Addendum No 001 Narrative

To Drawings and Specifications dated October 5, 2023

Walnut Grove Intermediate School – Science Classroom Modernization **West Covina Unified School District**

PBK Project No.: 202117
DSA A#: A# 03-123048
DSA File No.: 19-110

6 DIMOLITION FLOOR PLAN - BLDG 7
1/4" = 1'-0"

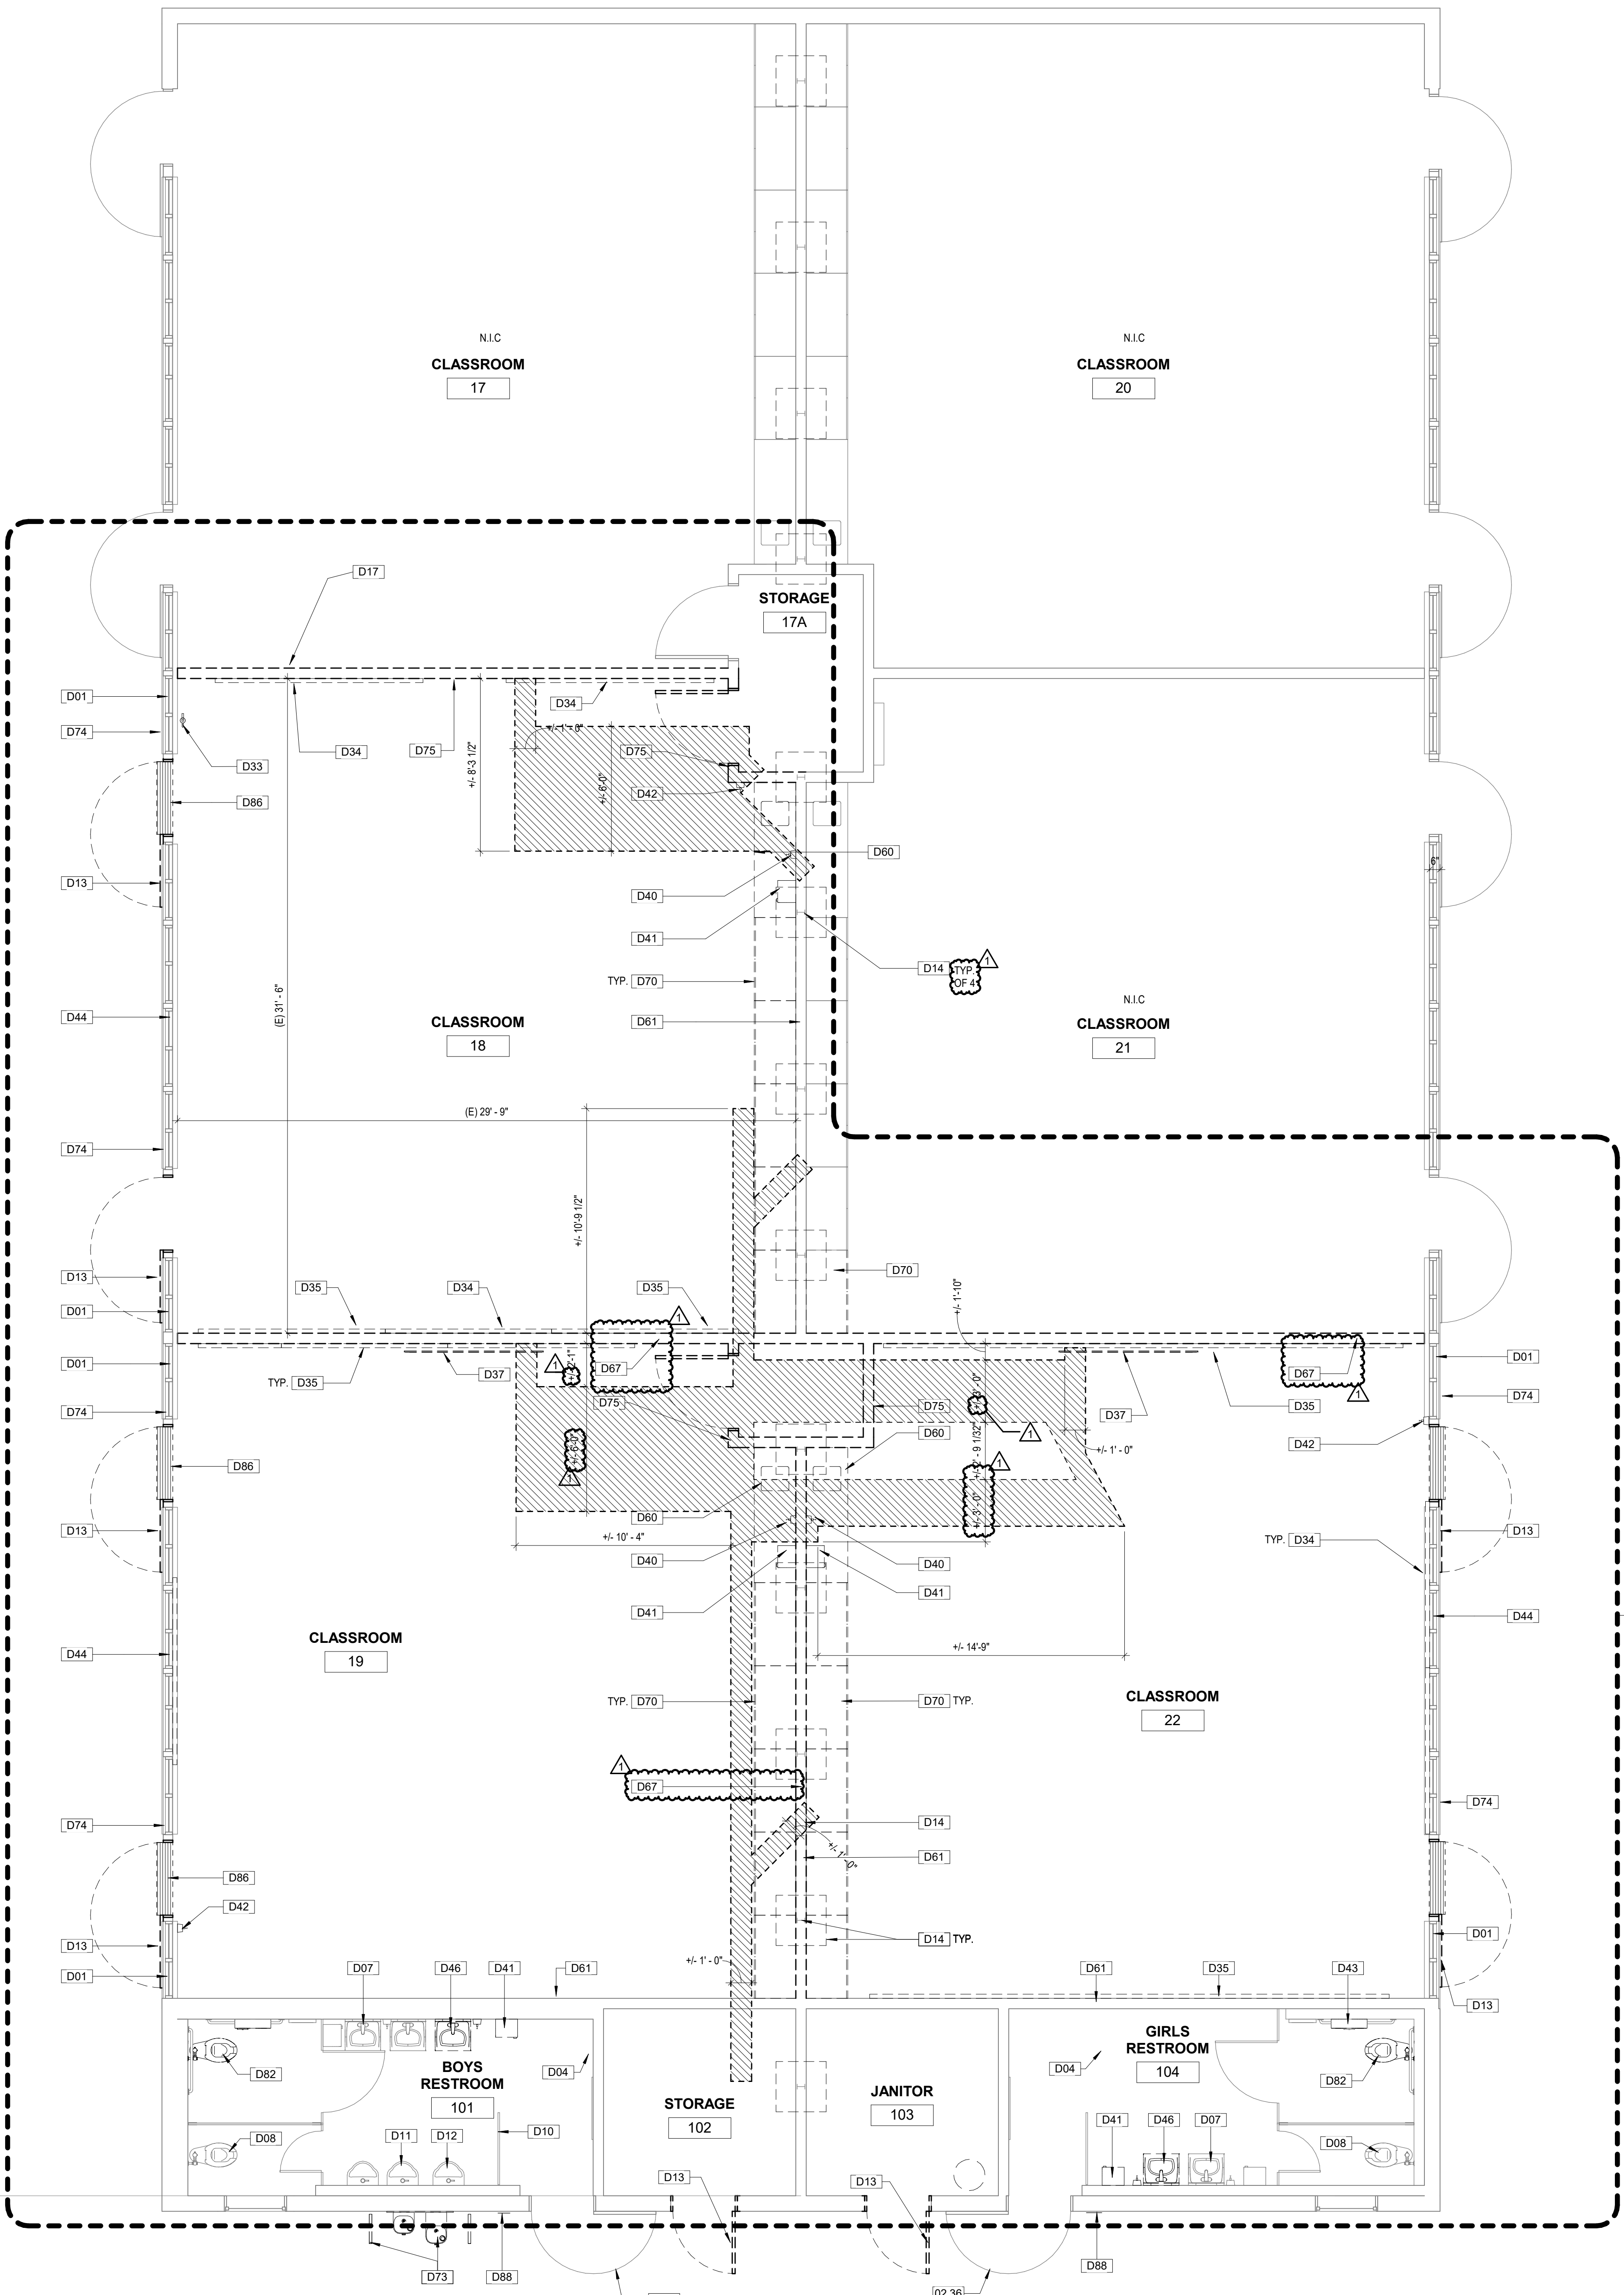
3. Item No. AD1-D2.01:
 - A) Fixed spelling on Keynote D46 "Mountain" to "Mounting"
 - B) Classroom 18, East wall - Added "TYP. Of 4" at the end of keynote D14 "(E) Structure column and footing to remain, protect in place."

- C) Room 19, North wall – Replaced keynote D75 "Demolish existing wall, door, and frame" with keynote D67 "Demolish Wall, (E) Columns to protect in place (Where Occurs)."

- D) Modified Dimensions on trenching from 4'-0" to 6'-0" and added +/- to trench dimensions.
 - E) Added Demolition note 32, which states "trenching demolition is approximate and needs to be coordinated with actual field conditions and detail requirements. see the remodel plan for additional information.

5 ENLARGED PARTIAL REMODEL PARKING LOT #1
1/8" = 1'-0"

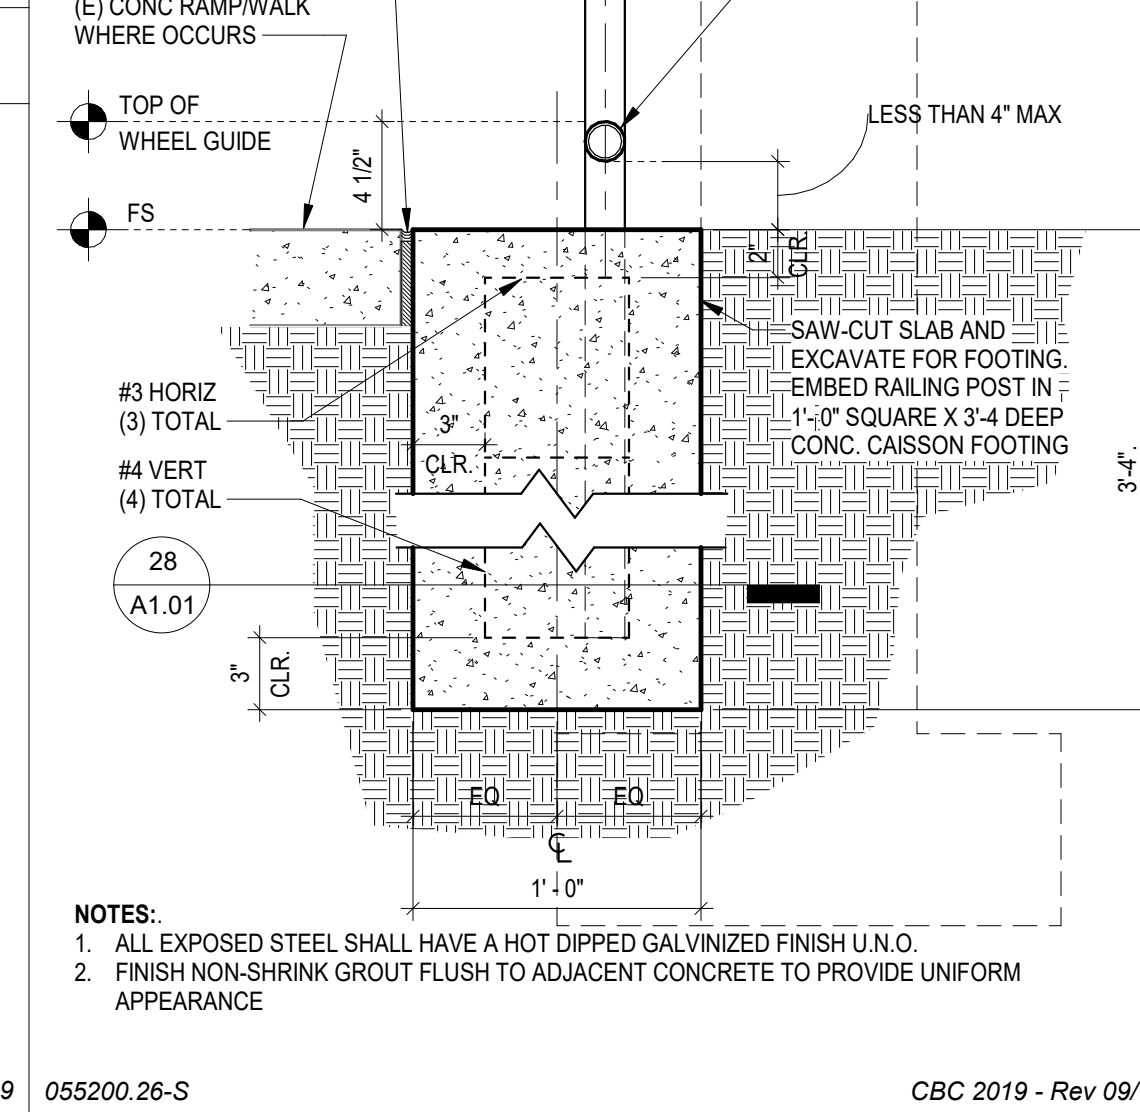
- D) Added keynote 32.06 which states “Parking Bumper – per detail 16/A1.01”
- E) Added keynote 32.07 which states “Accessible parking symbol – per detail 17/A1.01”
- F) Detail 5 Enlarged Partial Remodel Parking Lot #1 - Added keynote 32.06 and 32.07.

15 SIGN POST FOOTING
1 1/2" = 1'-0"

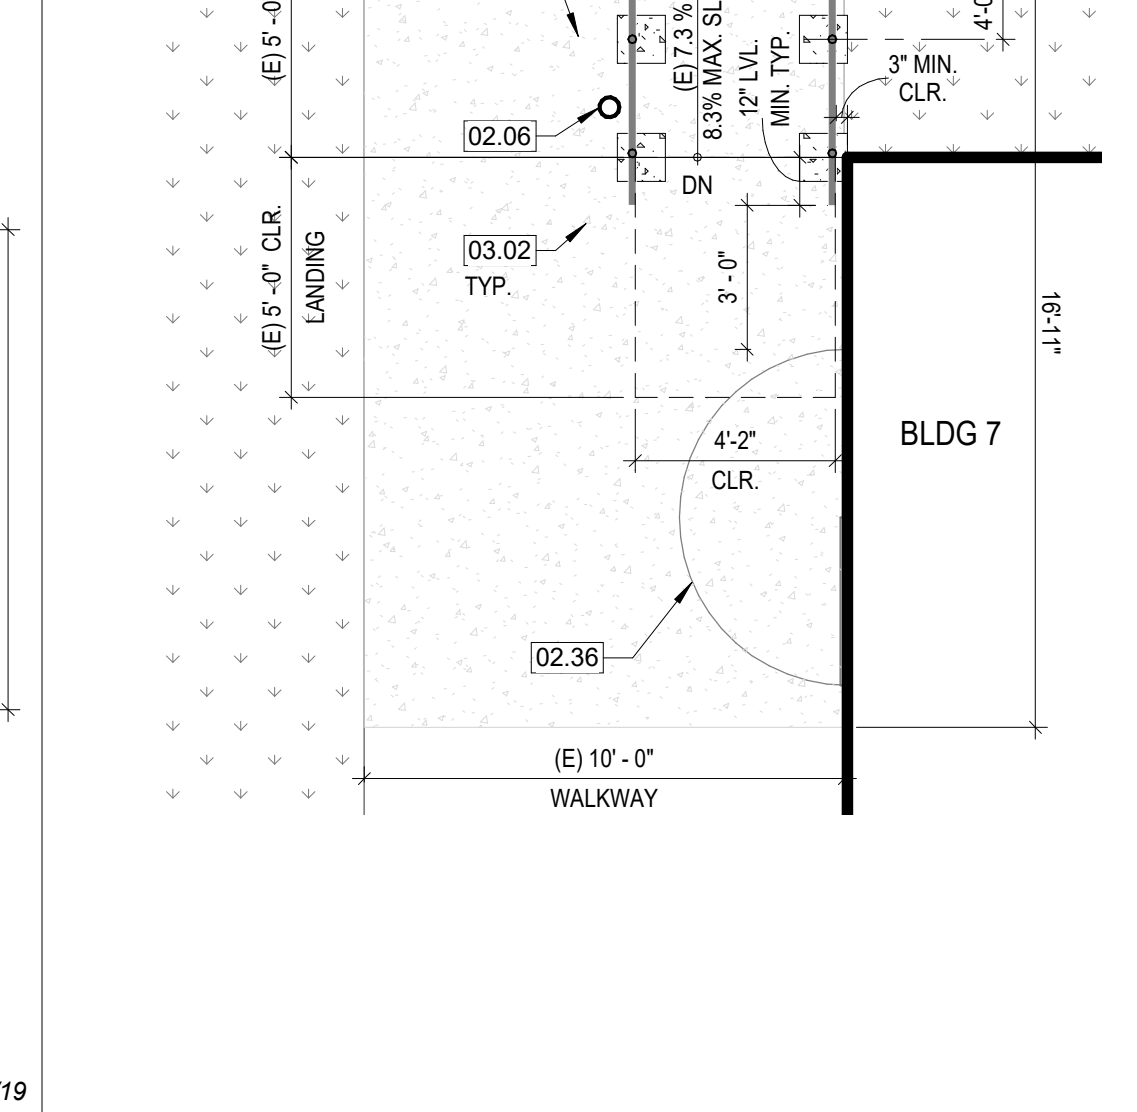
- C) Detail 15 – Sign Post Footing – Note 2% slope on top of the footing to divert water away from the sign post.

11 INTERIOR ELEVATIONS - GIRLS RESTROOM 104
1/4" = 1'-0"

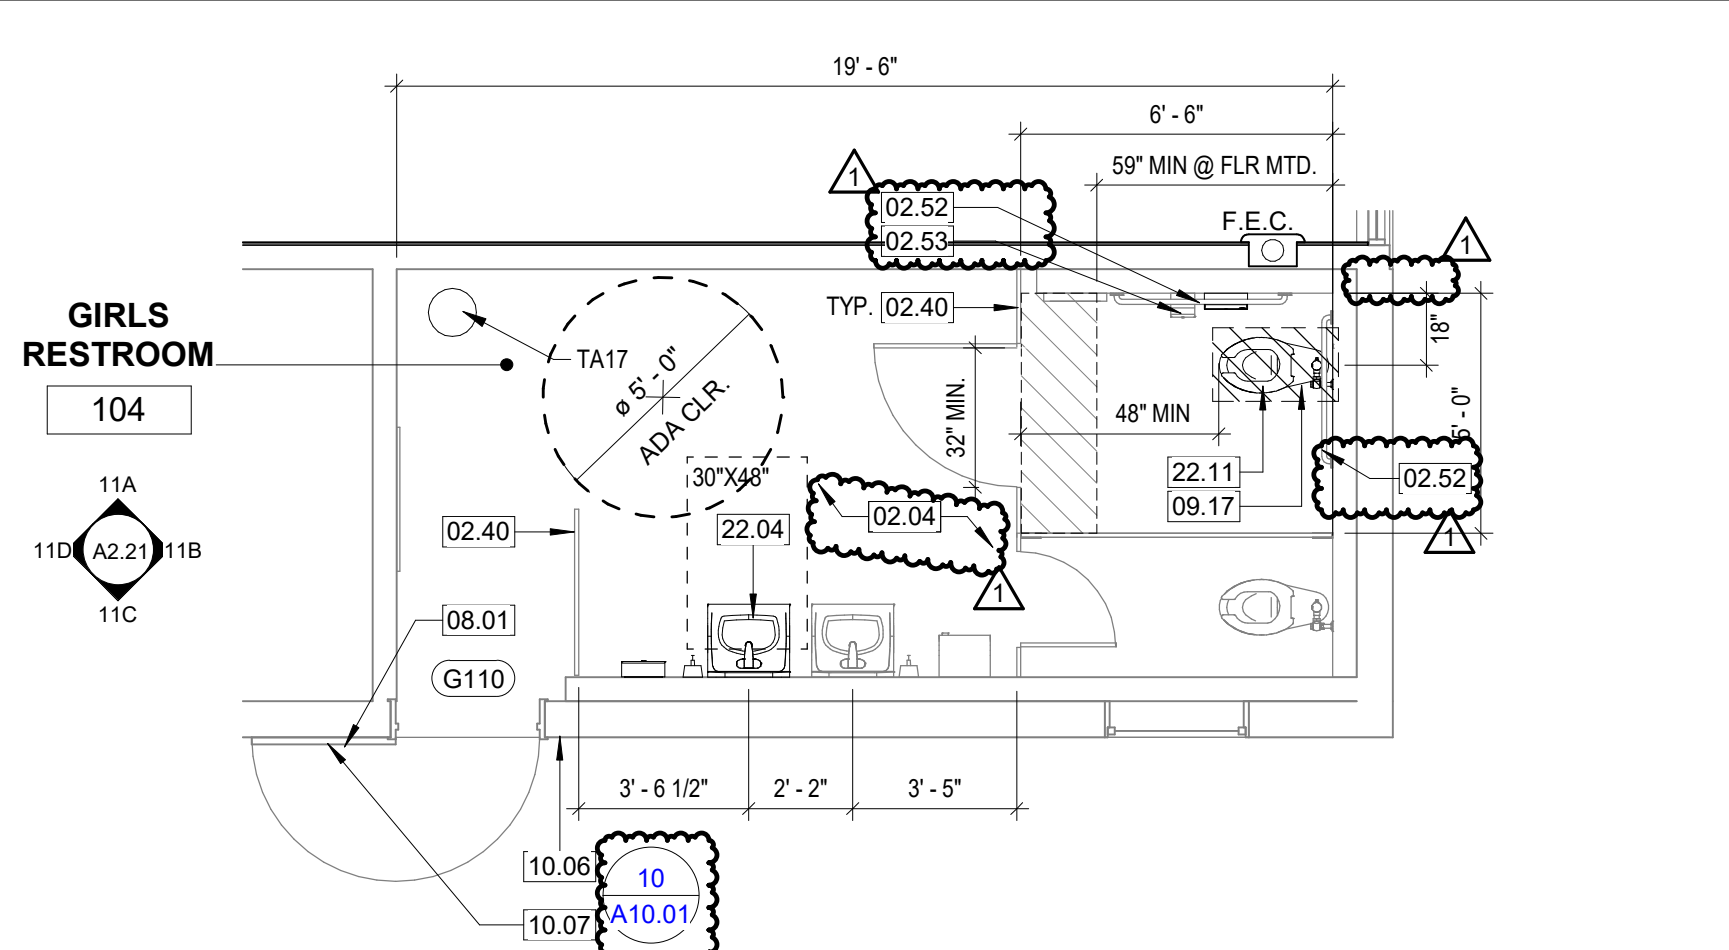
- C) Details 9A & 11A – “Added Keynote 2.53, (E) toilet paper dispenser to be removed and relocated per detail 5/A10.01”
- D) Detail 11C - Added keynote 02.48 which states “(E) Furred wall protect in place”.

- E) Details 11, 11A & 11B – added keynote 02.52 which states “(E) Grab bars to be removed and reinstall at accessible height per detail 5/A10.01
- F) Details 9, 9A & 9D – added keynote 02.52 which states “(E) Grab bars to be removed and reinstall at accessible height per detail 5/A10.01.

- G) Fixed spelling on keynote 22.04 to state “Mounting” instead of Mountain.
- H) Edited viewport 11 title to “Interior Elevations – Girls restroom 104.

5 ENLARGED REMODELED FLOOR PLAN - GIRLS RESTROOM 104
1/4" = 1'-0"

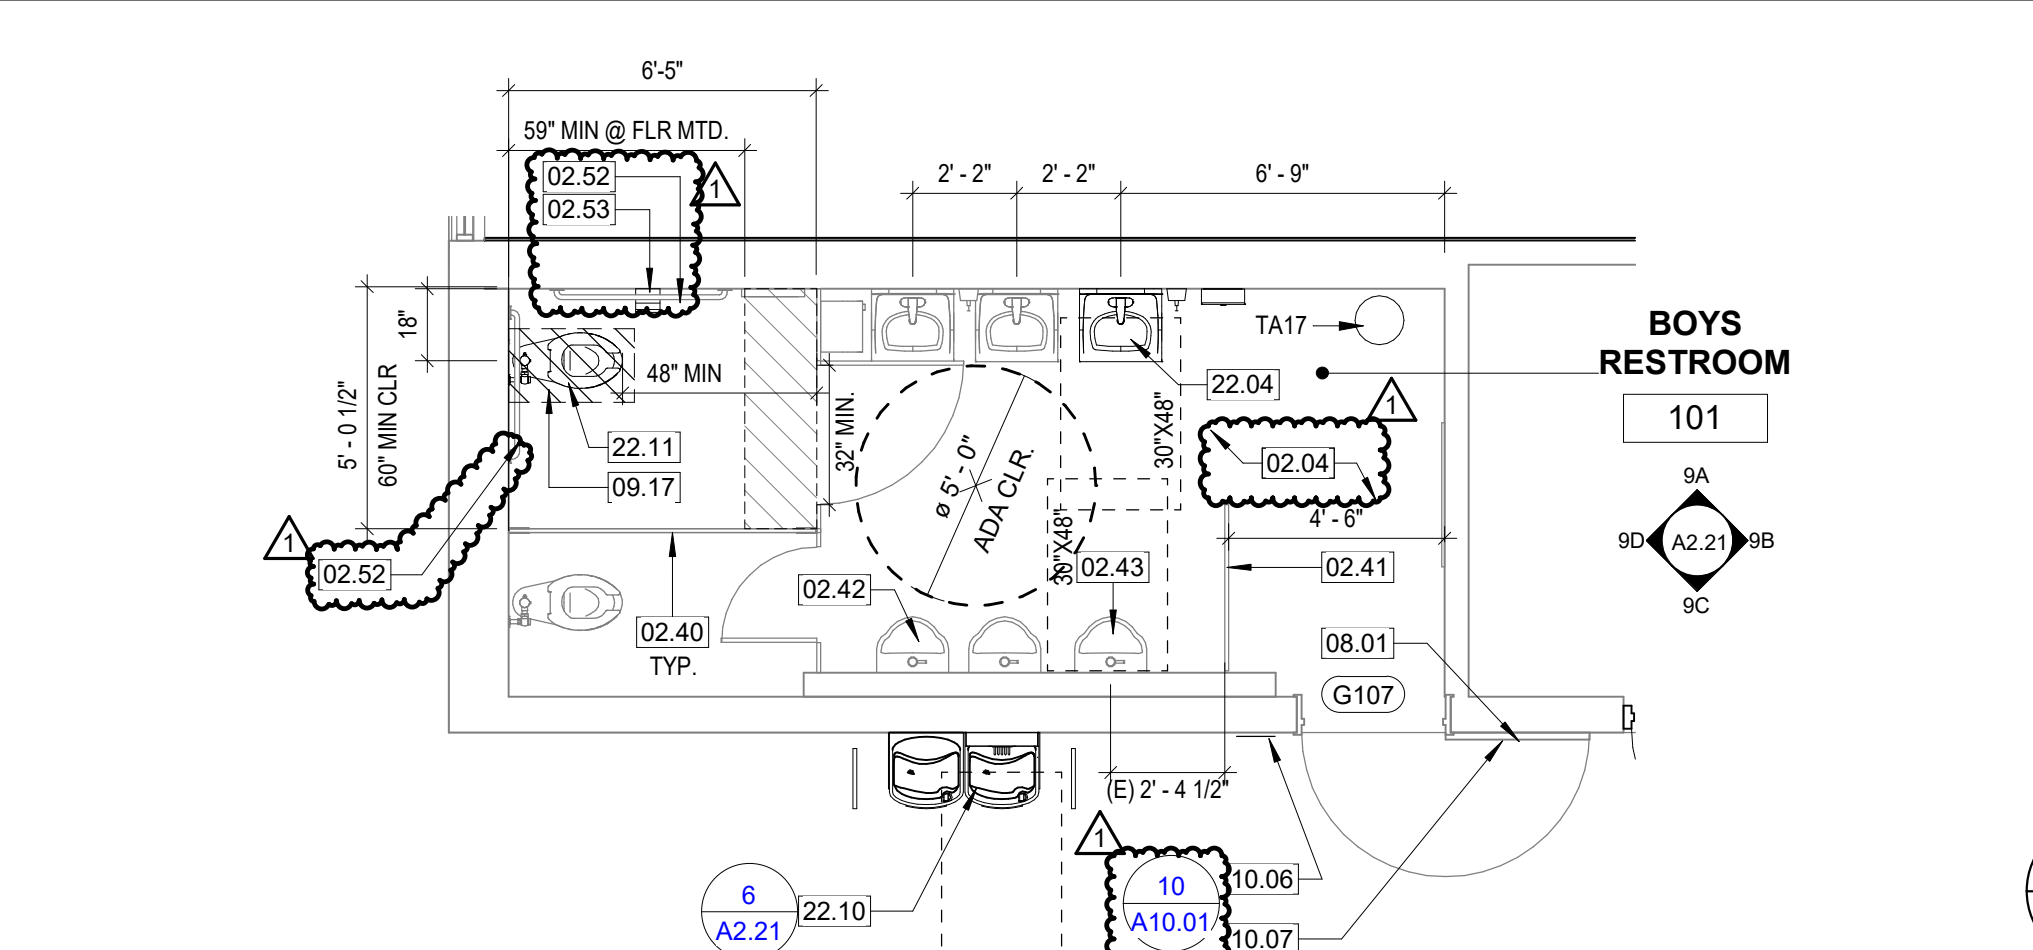
- A) Details 3 and 5 - Edited bubble callout view reference on the remodel plan legend to 10/A10.01 instead of 21/A10.01
- B) Details 3 and 5
 - a. Added keynote 02.04 which states “(E) Floor finish to remain, protect in place.”

- b. Added keynote 02.52 - “(E) Grab bars to be removed and reinstall at accessible height per detail 5/A10.01.
 - c. Added keynote 02.53 - (E) toilet paper dispenser to be removed and relocated per detail 5/A10.01”

- I) Added Crosshatch region to Viewports 9A, 9D, 11A, and 11B to indicate areas that will need patch and repair as needed.
- J) Added a dimension from face-to-face wall on viewport 5.
